Addendum No. 03

Memorial Stadium Modernization

Fieldhouse & Stadium

MADERA UNIFIED BID NO.: 073025
PBK PROJECT NO.: 20-51
DSA APPLICATION NO.: 02-121624 Fieldhouse
02-122784 Stadium

ES1.2

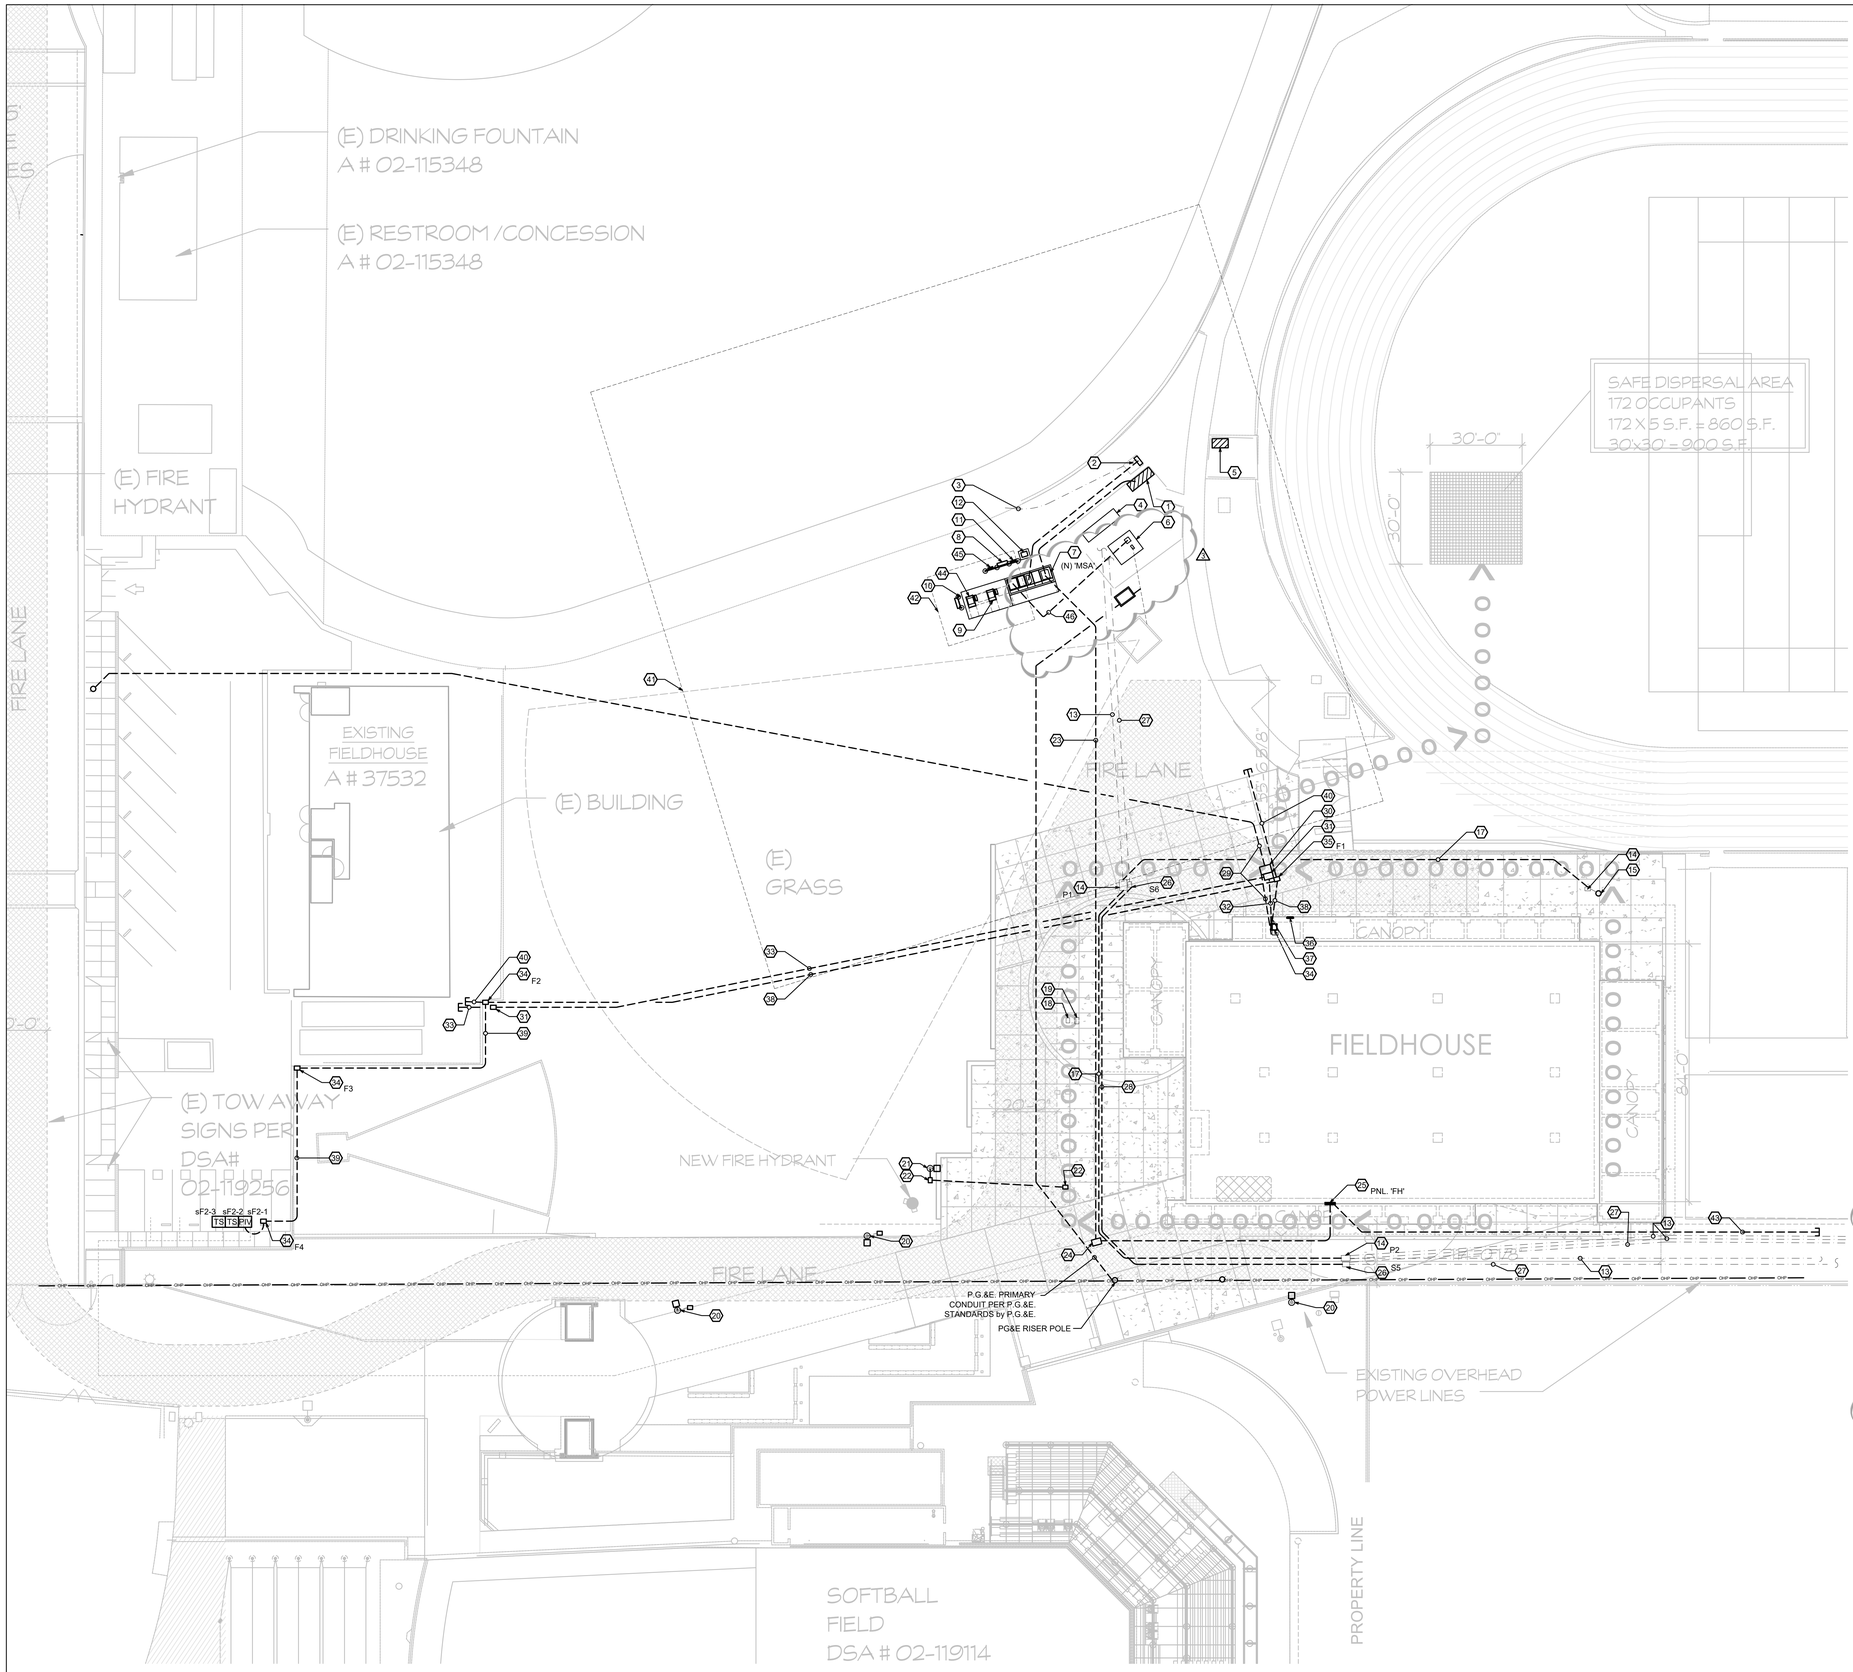
b. ES1.2 - ENLARGED DEMOLITION ELECTRICAL SITE PLAN
   - Modified Keynote 4.

E2.1

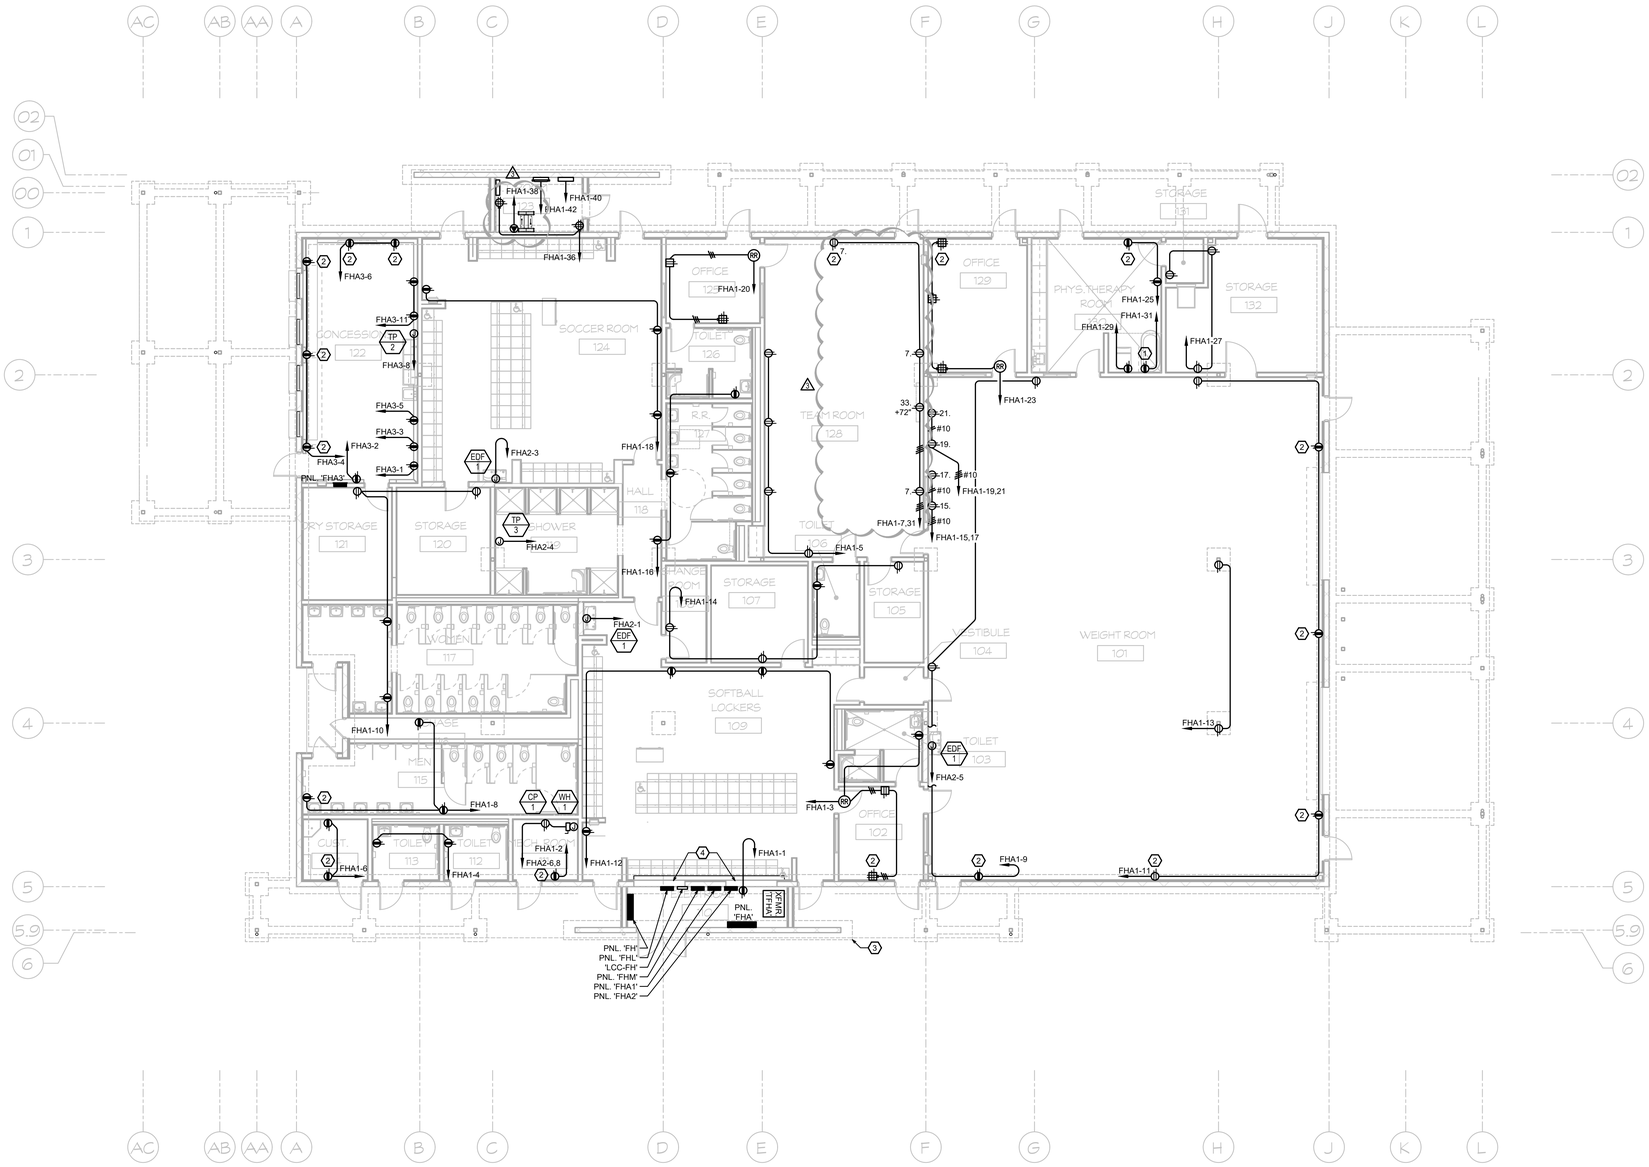
d. E2.1 - POWER PLAN
   - Changed Wall Mount IDF cabinet to Floor Mount 2-Post rack.
   - Changed receptacle for IDF.
   - Relocated receptacle on west wall of IT Room.
   - Added duplex TV receptacle in Reem Room 128.

E3.1

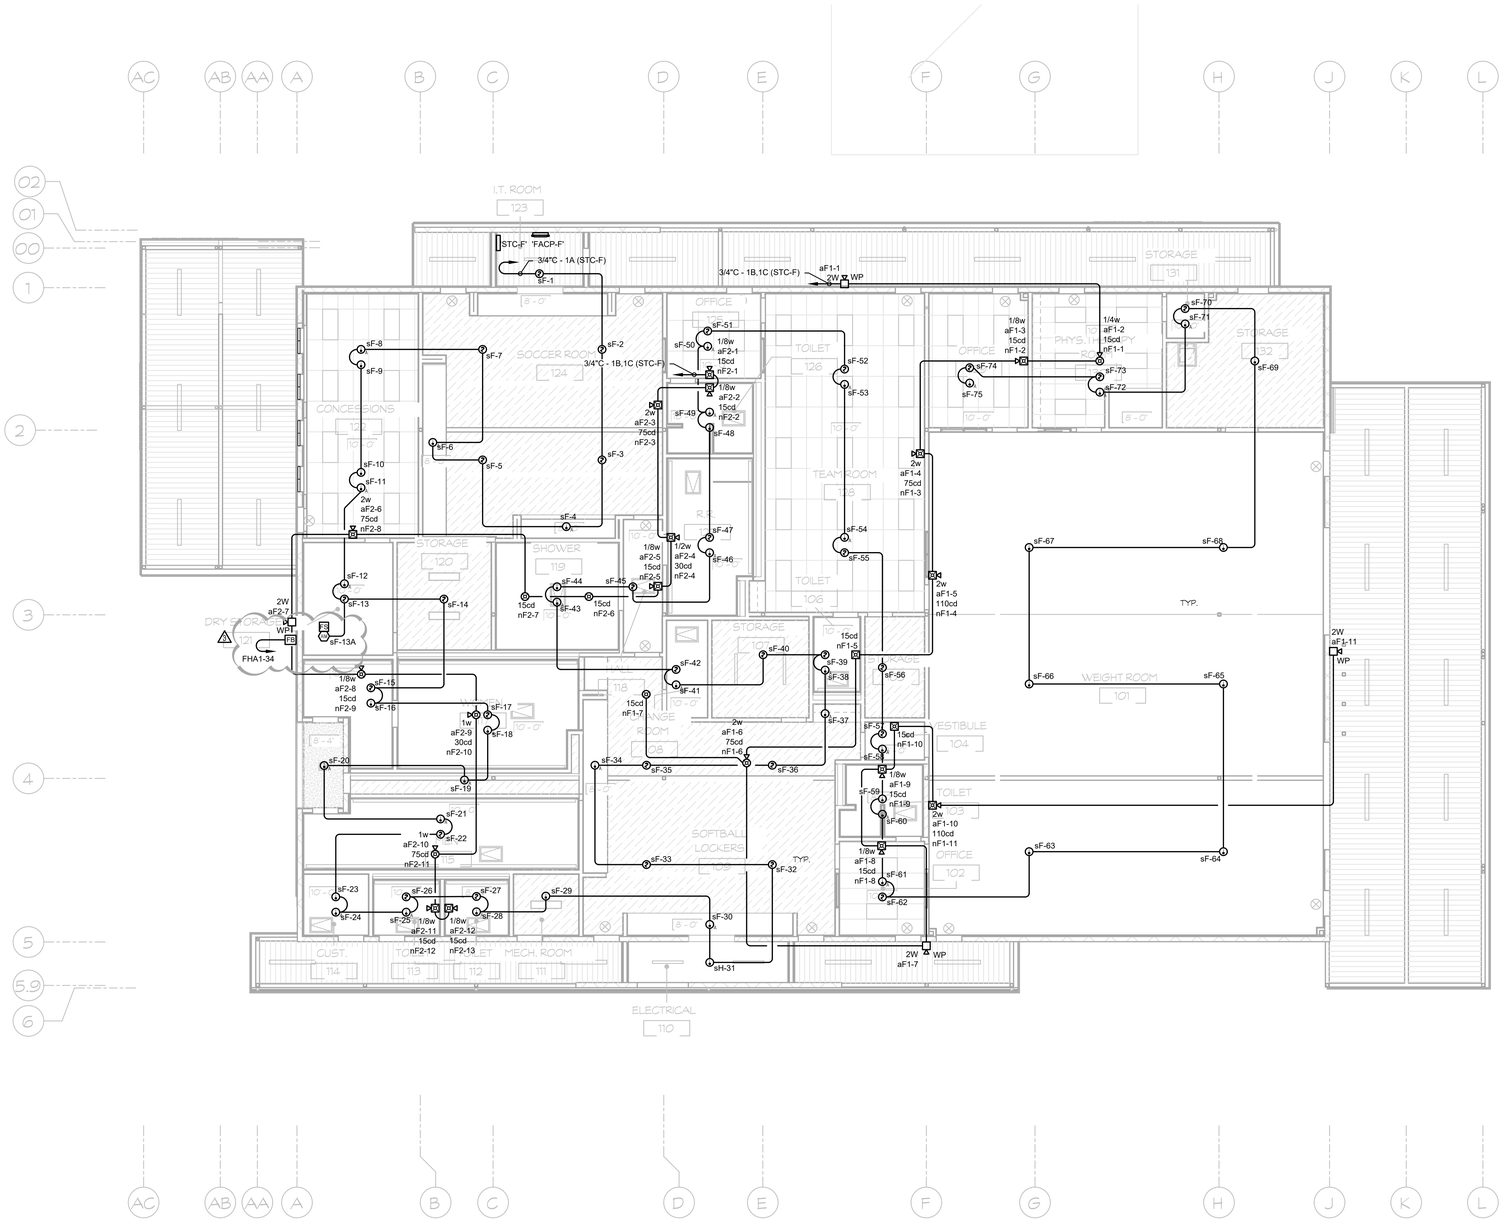
e. E3.1 - DATA/COMM PLAN
   - Added AV system in Team Room 128.

L5 FLOOR MOUNT 2 POST RACK MOUNTING DETAIL

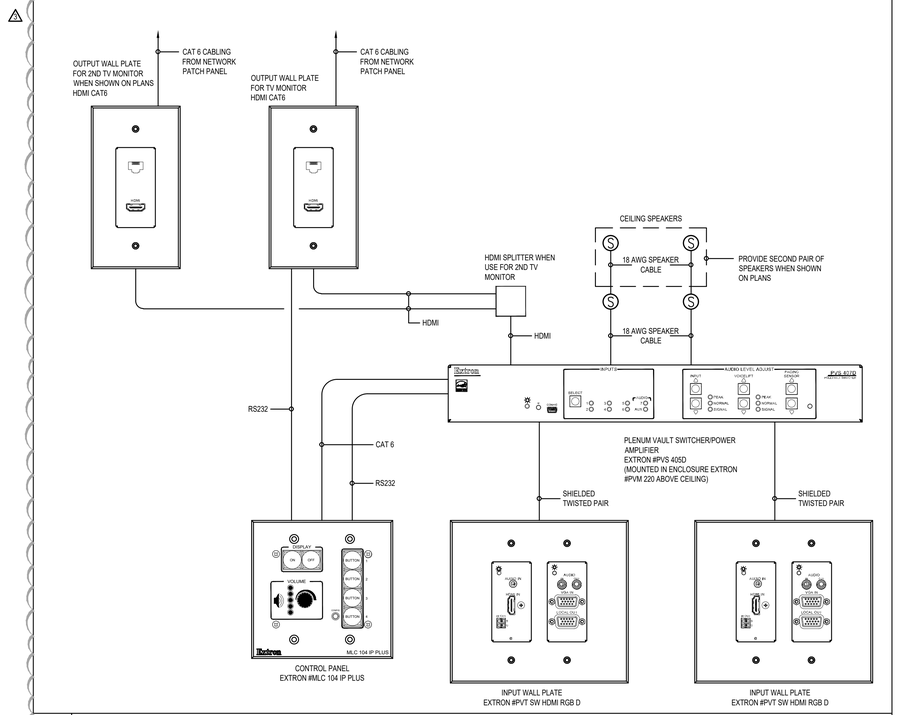
j. EX3.1 - ELECTRICAL LOW VOLTAGE DETAILS
   - Changed Wall Mount IDF cabinet to Floor Mount 2-Post rack.
   - Added detail E7.

C2.1

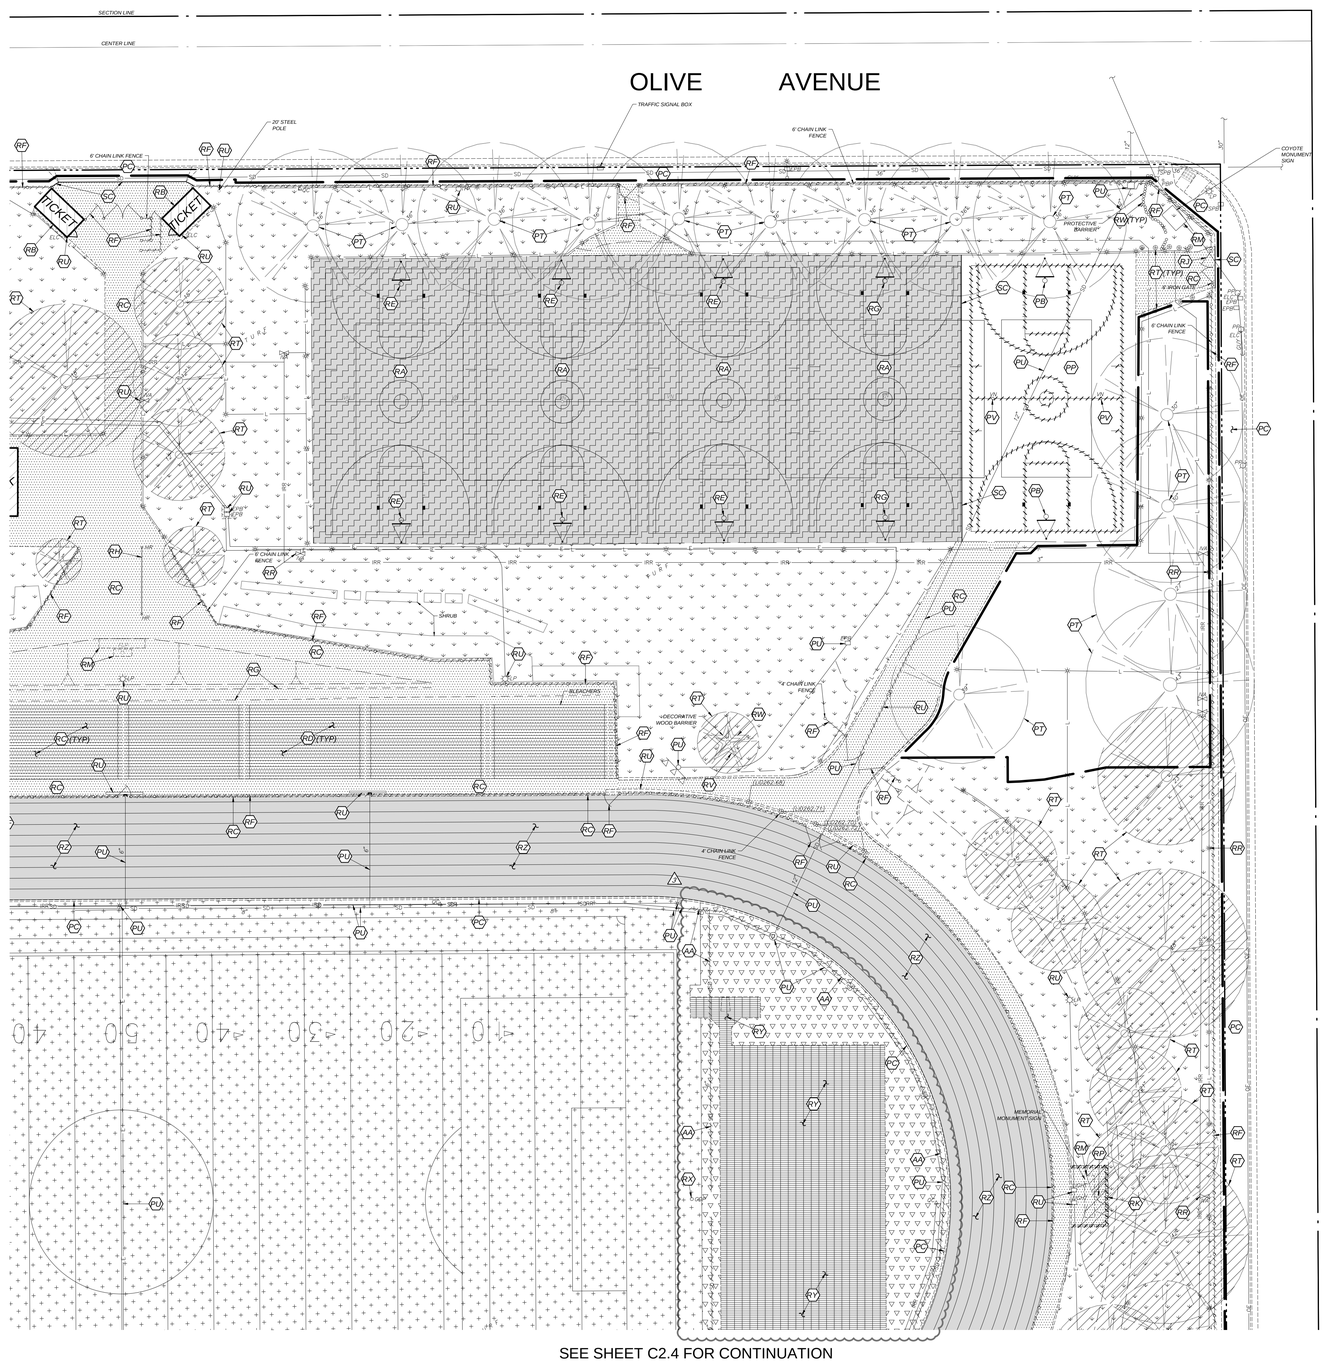
a. C2.1 – C2.4 DEMOLITION PLAN (4 pages)
   - Removed ‘PS’ in legend .
   - Included ‘AA’ and ‘RL’ in legend.
   - Revised existing scoreboard to be removed.

C3.1

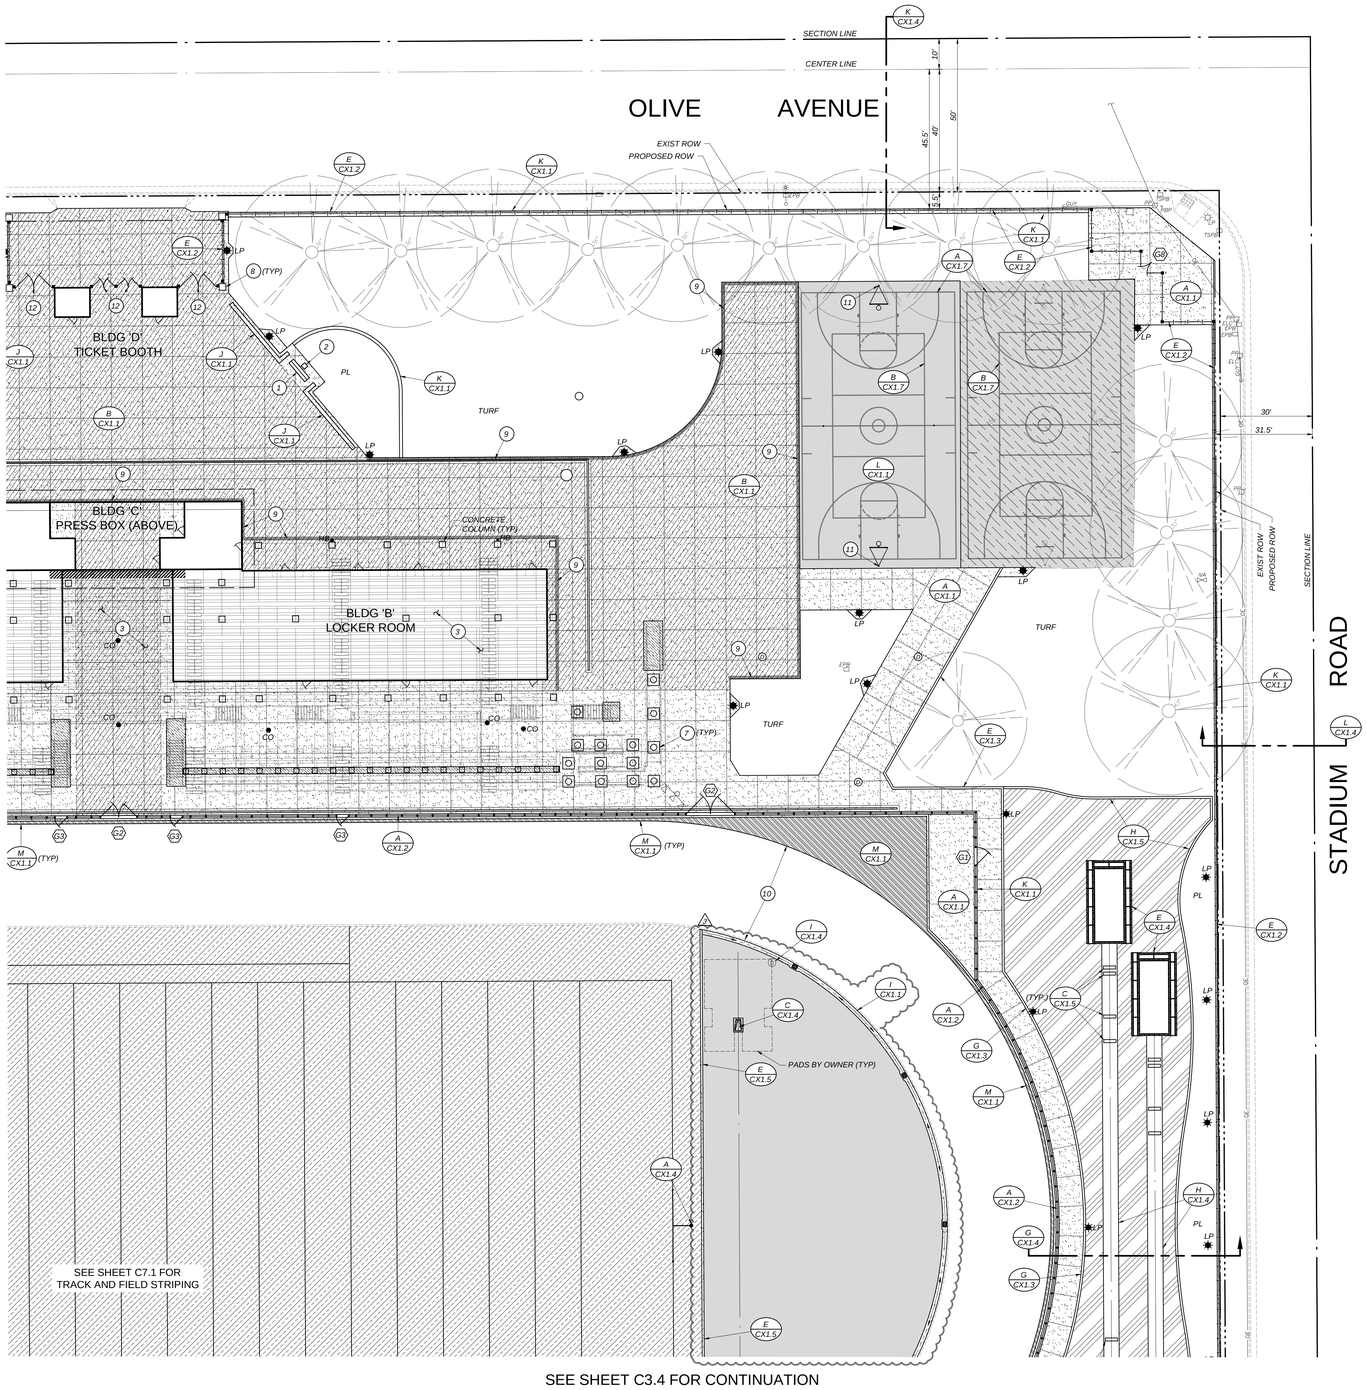
- Included additional removal of SD pipe.
b. C3.1 – C3.4 SITE PLAN (4 pages)
   - Revised turf “D” end areas with asphaltic concrete pavement for track surfacing.

- Included concrete header separating field and pavement areas.
   - Included concrete valley gutter with drain inlets and piping.
c. C4.1 – C4.5 HORIZONTAL CONTROL PLAN AND TABLE (5 pages)
